Intersection ID: 44822	Main Street: GOLDEN_RIDGE_LN	Cross Street: HIRAM_ST	Location:	NE
ADA ID: EDB8E4396A2F	Ramp Type: PerpDiag	Initial Pass/Fail: Fail	Overall Compliance: No	Severity Score: 33.75

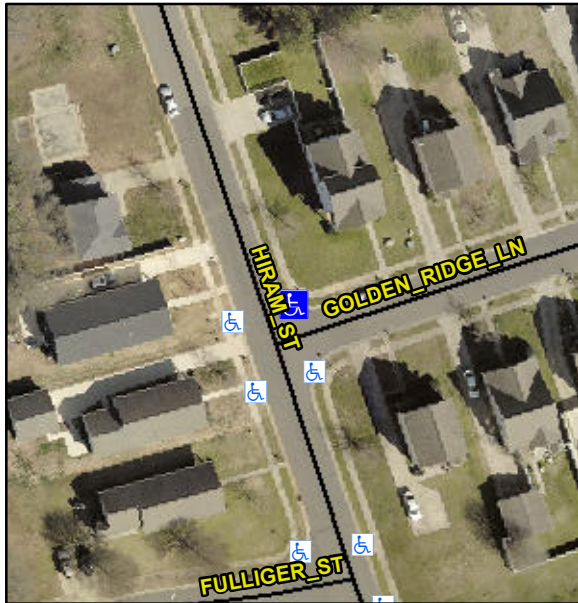
Not Found, R304.5.1, R304.5.3

Compliance	Description	Data	Compliance	Description	Data
N/A	Ramp Length (in)	94.0	Yes	Ramp Slope (%)	5.3
No	Ramp Width (in)	40.0	No	Ramp XSlope (%)	15.4
N/A	Flare Type LT	N/A	N/A	Flare Type RT	N/A
N/A	Flare Slope LT (%)	N/A	N/A	Flare Slope RT (%)	N/A
N/A	Flare Traversable LT?	N/A	N/A	Flare Traversable RT?	N/A
N/A	Landing Length (in)	N/A	N/A	DWS Provided?	N/A
N/A	Landing Width (in)	N/A	N/A	DWS Contrast?	N/A
N/A	Landing Slope (%)	N/A	N/A	DWS Length (in)	N/A
N/A	Landing X Slope (%)	N/A	N/A	DWS Full Width?	N/A
N/A	Landing Curb? (Y/N)	N/A	N/A	DWS Offset (in)	N/A
N/A	Shared Landing?	N/A			
N/A	Gutter Ponding?	N/A	N/A	Gutter Slope (%)	N/A
N/A	Gutter Lip Ht (in)	N/A	N/A	Gutter X Slope (%)	N/A
N/A	Painted X Walk1?	No	N/A	Painted X Walk2?	No
	X Walk 1 Direction	To W		X Walk 2 Direction	To S
N/A	X Walk 1 Width (in)	N/A	N/A	X Walk 2 Width (in)	N/A
	X Walk 1 Slope (%)	5.0		X Walk 2 Slope (%)	2.9
	X Walk 1 X Slope (%)	3.6		X Walk 2 X Slope (%)	7.6

Remove & Replace Curb Ramp With Two New Directional Ramps or Equivalent.
